**IPCC Synthesis Report
Fourth Assessment Report**

Comments on the Final Government Draft

– TOPIC 5 (all batches to 7 November 2007) –

November 7, 2007

Proposal by the Government of Belgium (Refer to Comment 5-A-19)

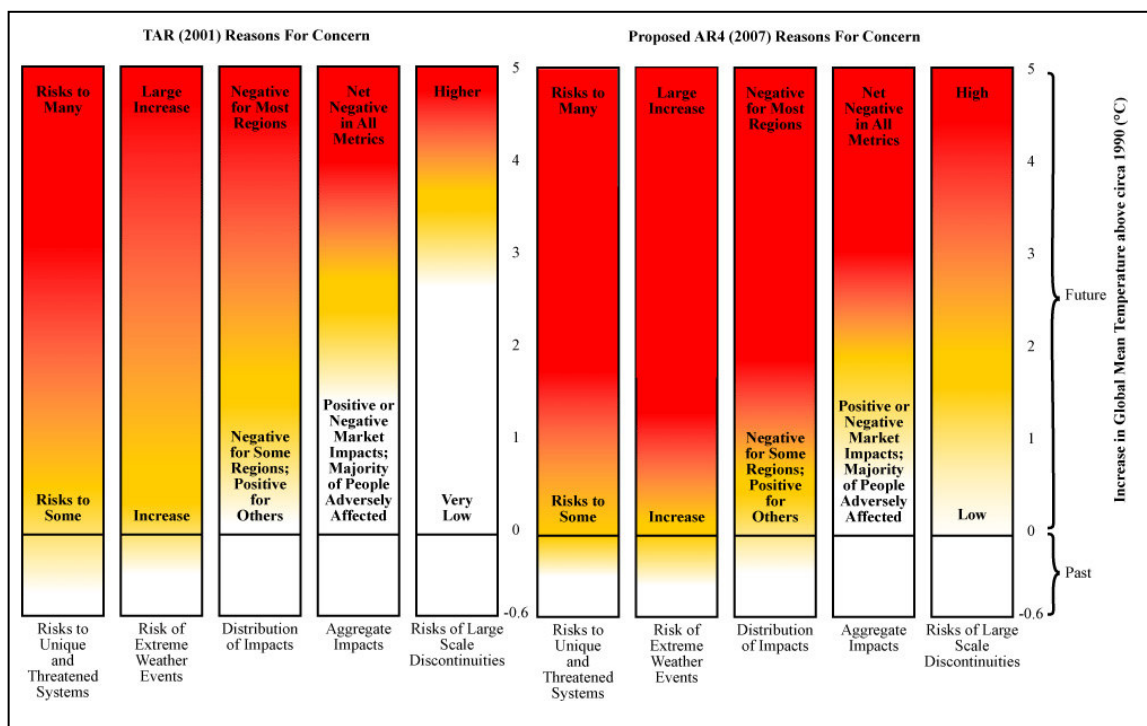
| Topic - Batch - Comment | Page | Line | To Page | To Line | Comment |
|--------------------------------|-------------|-------------|----------------|----------------|---|
| 5-A-19 | 2 | 3 | 2 | 10 | This sentence about "Reasons for concern" (RFC) is very important for policy-makers, and the justification contained below (section 5.2) is most welcome, even if it could be more precise in some areas. However, we believe there would be significant added value to the SYR if the points made about the "stronger" reasons for concerns could be illustrated graphically by an update to the RFC diagram contained in the TAR. Such an update was actually proposed by the WGII Chapter 19 authors at the WGII Plenary in Brussels, but the time did not allow a full discussion of this inclusion then, and several delegations suggested that it should be part of the Synthesis Report. To facilitate the discussion, we include here the figure proposed by the WGII Chapter 19 author team in Brussels. This diagram does not contain information that has not been assessed in AR4, it is only an illustration of the material contained in section 5.2. The plot is contained in the following comment, followed by the proposed caption. We believe the added value of this RFC diagram is very high in terms of outreach to policy-makers and the public. [TSU Note: Refer to additional material; "3. Reasons for Concern Diagram"] (Government of Belgium) |

| Topic - Batch - Comment | Page | Line | To Page | To Line | Comment |
|--|-------------|-------------|----------------|----------------|--|
| 5-A-32 | 2 | 28 | 2 | 28 | New Figure to add, as proposed by the WGII Chapter 19 author team at the Brussels Plenary: PLEASE INSERT HERE THE CONTENT OF FILE "UPDATED RFC" IN ANNEX, as the macros presumably prevent us from doing it; We will also post it on www.climate.be/RFC. (Government of Belgium) |
| 5-A-33 | 2 | 28 | 2 | 28 | Caption for new proposed Figure (Updated Reasons for concern): "The consequences from climate change are expressed by reasons for concern (RFC) (Burning embres diagram TAR & AR4). Climate change consequences are plotted against increases in global mean temperature (°C) after circa 1990. Impacts caused by warming up to 1990 are also considered. Each column corresponds to a specific RFC, and represents additional outcomes associated with increasing global mean temperature. The color scheme represents progressively increasing levels of risk, and should not be interpreted as representing "dangerous anthropogenic interference." It should be noted that this figure addresses only how risks change as global mean temperature increases, not how risks might change at different rates of warming. Furthermore, it does not address when impacts might be realized, nor does it account for the effects of different development pathways on vulnerability. Figure 1A displays the Reasons for Concern from the IPCC TAR (Smith et al., 2001). Figure 1B presents the update of the Reasons for Concern." (Government of Belgium) |

The consequences from climate change are expressed by reasons for concern (RFC). Climate change consequences are plotted against increases in global mean temperature (°C) after circa 1990. Impacts caused by warming up to 1990 are also considered. Each column corresponds to a specific RFC, and represents additional outcomes associated with increasing global mean temperature. The color scheme represents progressively increasing levels of risk, and should not be interpreted as representing "dangerous anthropogenic interference." It should be noted that this figure addresses only how risks change as global mean temperature increases, not how risks might change at different rates of warming. Furthermore, it does not address when impacts might be realized, nor does it account for the effects of different development pathways on vulnerability. Figure 1A displays the Reasons for Concern from the IPCC TAR (Smith et al., 2001). Figure 1B presents our update of the Reasons for Concern.
